**PORSCHE**

# Stop Delivery

*Taycan (1YA / 1YB), 2020-2022*

AMC1 Stop Delivery – Hazard Warning Lamp – automatic activation re-programming

## Installation position:

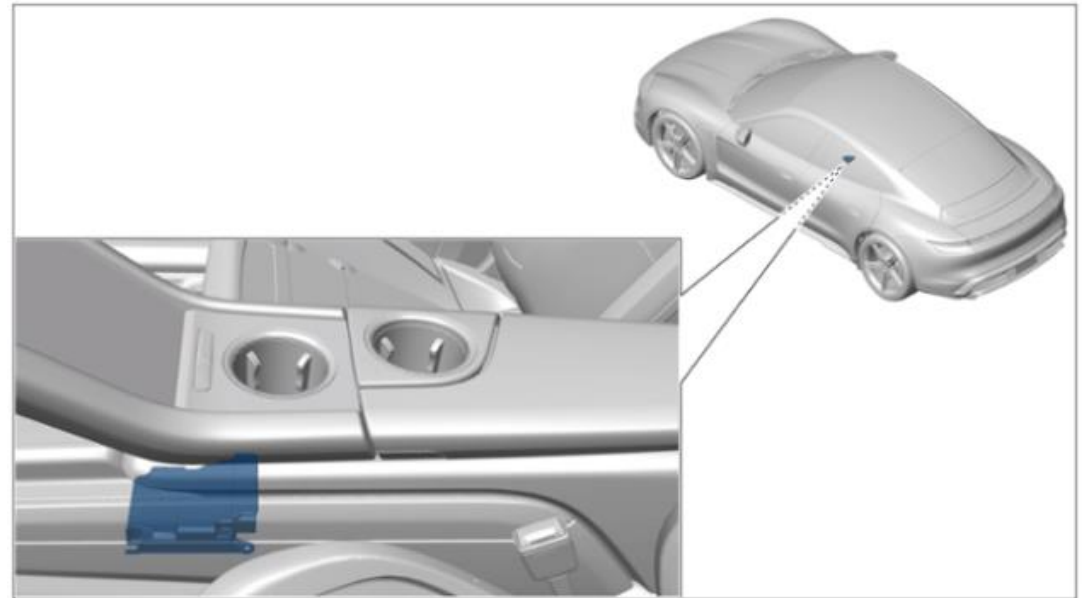
To correct this behavior and to bring affected vehicles into regulatory compliance, the Airbag control unit has to be re-coded with an updated software before vehicle delivery.

(1) Airbag control unit (**Re-coding**)
